AIRWORTHINESS DIRECTIVE

SZD-9 BOCIAN 1E SAILPLANES

Crack inspection of elevator actuating rod fork end.

BULLETIN NR BE-025/82 "BOCIAN 1E"

Fig.1.

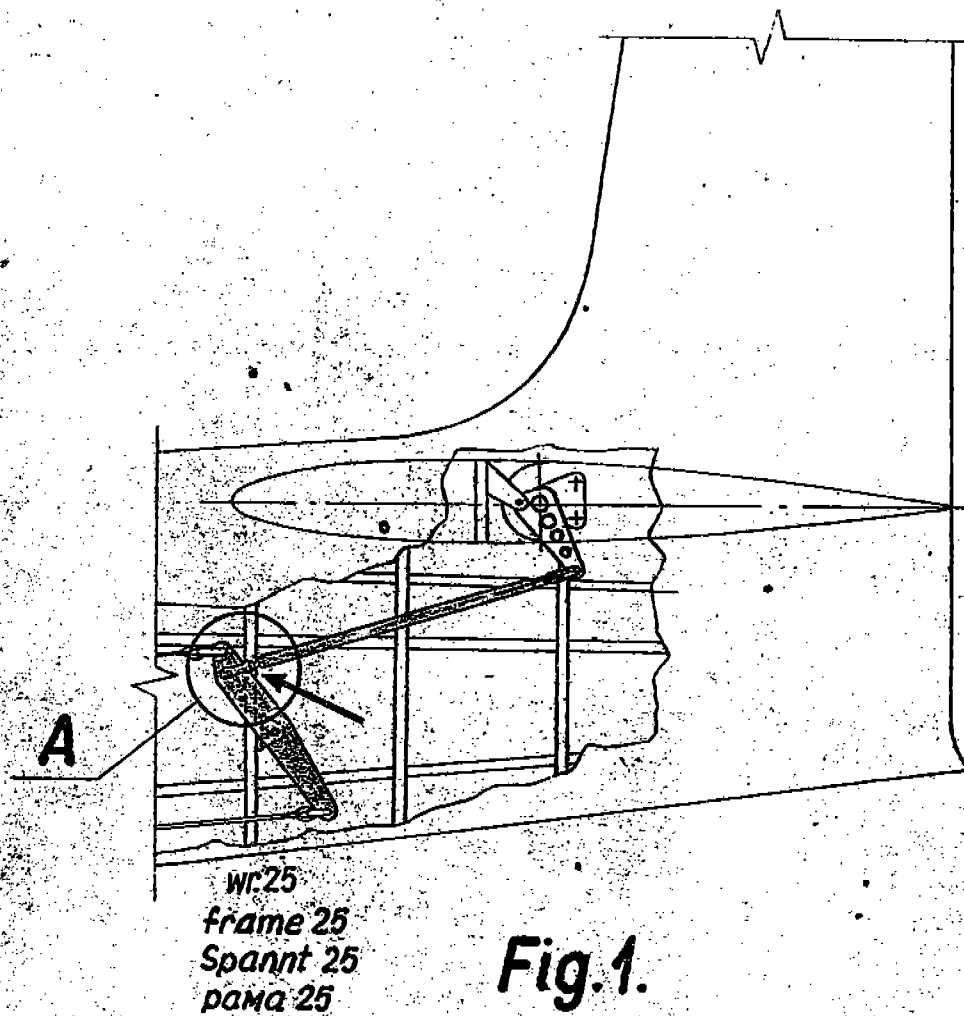
- 4.4. Degrease the end in gasoline and inspect /using the 5 times magnifying glass/ the threaded part of the end particularly on the groove side and pay attention for cracks at the thread root. In case the cracks were found the new end shall be installed.
- 4.5. Reassemble the push-rod and check the correct elevator deflections.

location of appearing of cracks
Stelle der Rissbildung
место возникновения трещин

Fig.2.

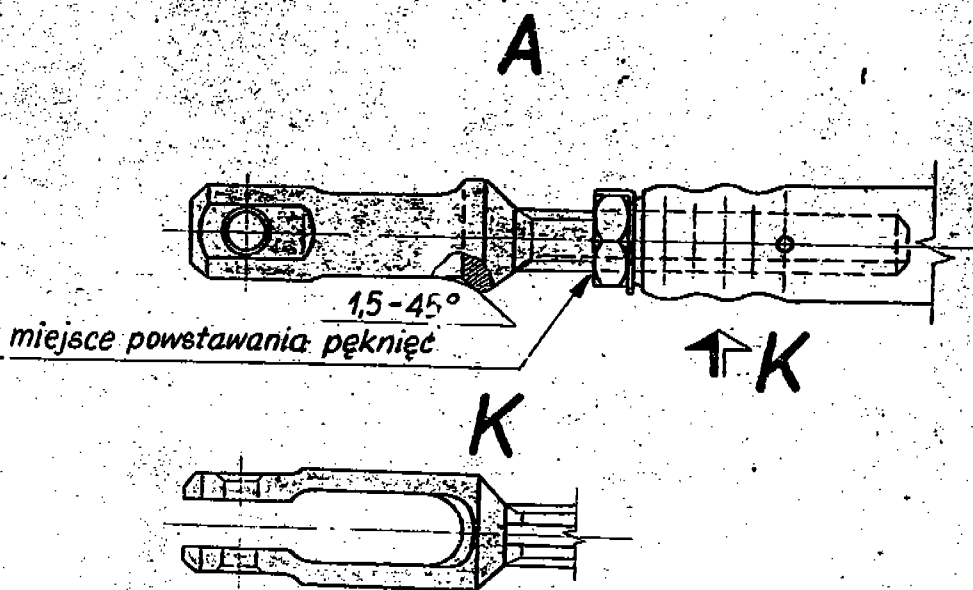
- 4.1. Disassemble the push-rod out of the elevator lever.
 - 4.2. Disassemble the connection of push-rod fork end with the lever on the frame No 25. Take out the push-rod. If the push-rod end engages the above mentioned lever during the normal elevator deflection /traces on lever/ the end may be filed as shown on sketch Fig. 2.
 - 4.3. Dissecure and screw out the fork end /remember to mark its original alignment in respect to control circuit adjustment/.
- Pay attention that the end is not bent in. The bent end is not allowed to be aligned but the new one shall be installed.

- In such a case the adjustment of cables for the correct elevator deflections should be checked.
- The collision of end and lever shall be avoided.
- The small fileing of lever edge at 45° is allowed but it must be protected with pen for metal /see fig. 2/.
